MONTGOMERY COUNTY HISTORIC PRESERVATION COMMISSION
STAFF REPORT

Address:	19000 Muncaster Rd., Derwood	Meeting Date:	12/6/2023
Resource:	Individually Listed Master Plan Site (The Ridge #22/15)	Report Date:	11/29/2023
Applicant:	Richard P. Miller	Public Notice:	11/22/2023
Review:	HAWP	Staff:	Dan Bruechert
Permit No.:	1048102 RETROACTIVE	Tax Credit:	n/a
Proposal:	New Fencing and Lights for Outdoor Riding Arena

The applicant proposes to construct wood board fencing to enclose a riding ring in front of the house with six 25' (twenty-five feet tall) wooden poles with attached lights.

SITE PLAN

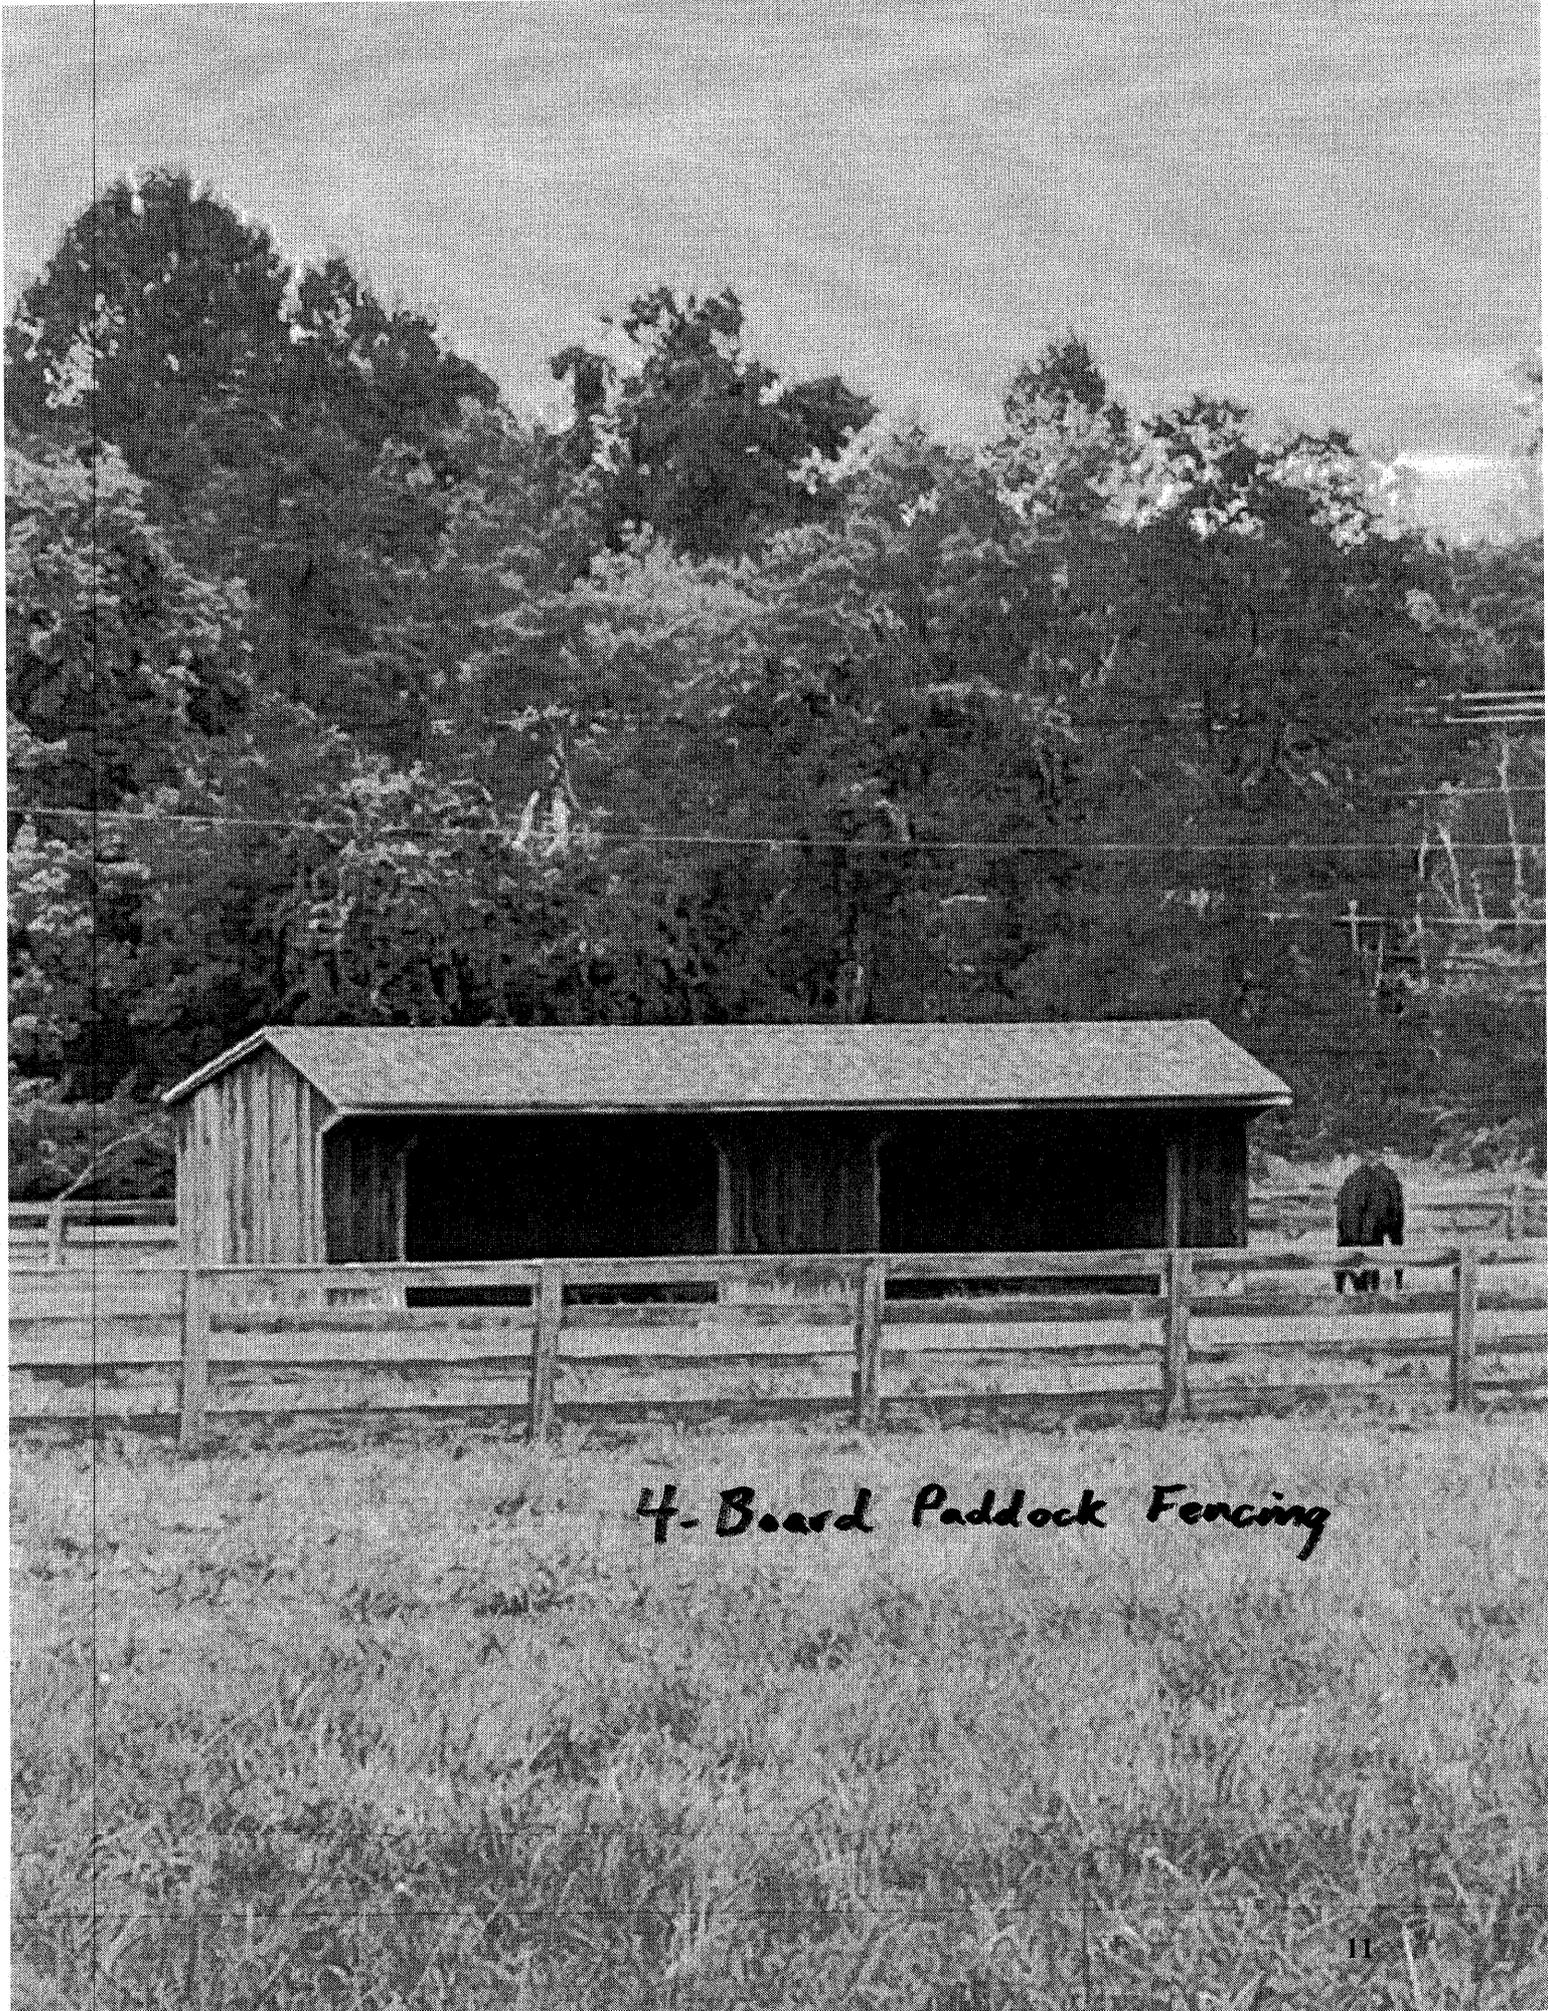
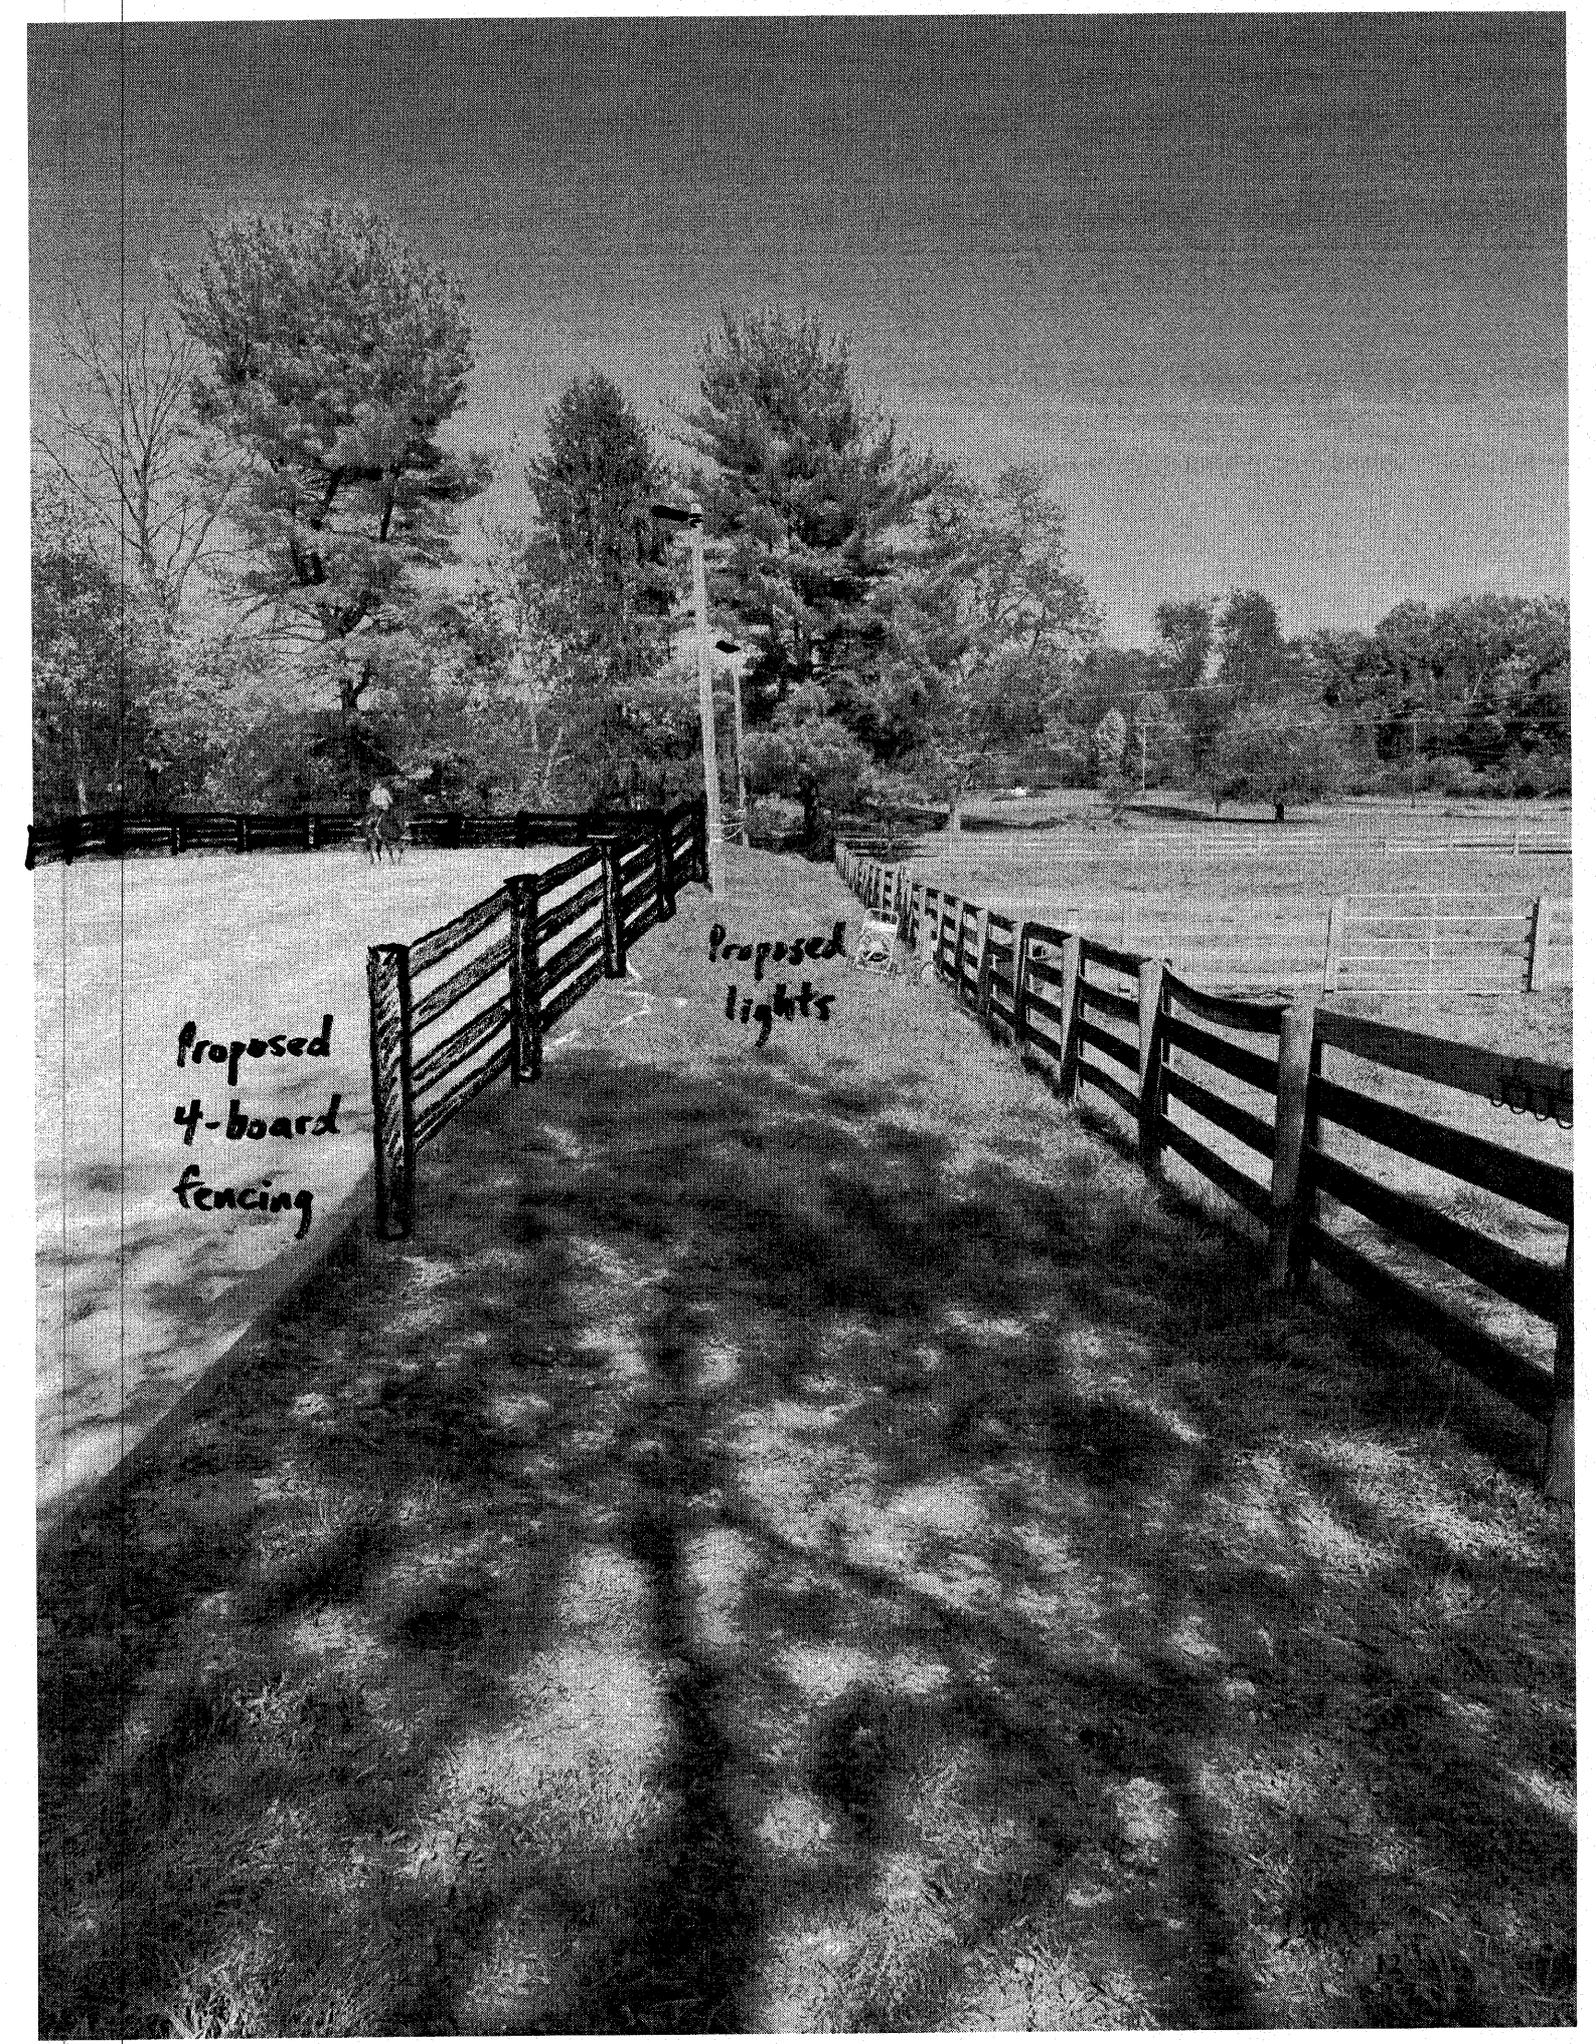
Staff finds the proposed fence will match the existing paddock fence. Staff finds that the fence is compatible with the design, materials, and dimensions of the Master Plan Site, and is compatible with typical paddock fencing commonly found in rural areas and used for the purposes of containing livestock,

delineating property boundaries, and fencing off riding arenas or other speciality-use areas within a farm property. Adding a layer of fencing, approximately 500' (five hundred feet) from Muncaster Rd. will not detract from the character of the Master Plan Site and Staff recommends the HPC approve the proposed fence.

The next proposed change on the site is the installation of six wood telephone poles with LED light fixtures. To provide electricity to the lights, the applicant proposes to cut a trench from the hay barn to the proposed riding ring. The trench will be approximately 4" (four inches) wide and 18" (eighteen inches) deep. The 25' (twenty-five foot tall) telephone poles will be sunk 5' feet into the ground, leaving 20' (twenty feet) exposed. The applicant proposes to install an LED light fixture on each of the poles. The lights measure 13" × 32.5" (thirteen inches wide, by thirty-two and one-half inches long).

“The light must direct light downward. No light should go over the property line, so it should be 0.0 footcandles at the property line. Also, illumination is prohibited after 10 PM on Friday and Saturday and 9 PM all other days of the week.”

Staff finds the proposed poles and lights will not have a significant effect on the character of the site. The six poles will be spaced far enough from one another that they will not disrupt the sense of openness in the front of the property. Staff additionally finds wood is the appropriate material for these poles as they will dull and blend whereas a metal pole would likely appear too shiny to be compatible. The black lights are not so large that they will overwhelm the character of the site. Additionally, Staff finds the proposed LED fixtures will be easier to position so that the light satisfies the zoning requirement, outlined above.

Staff recommends the HPC **approve the HAWP** with **one** condition:

1. The approved documents for this HAWP not be released until the condition for HAWP #1045917 (approved on 10/25/2023) has been satisfied and verified by Staff.
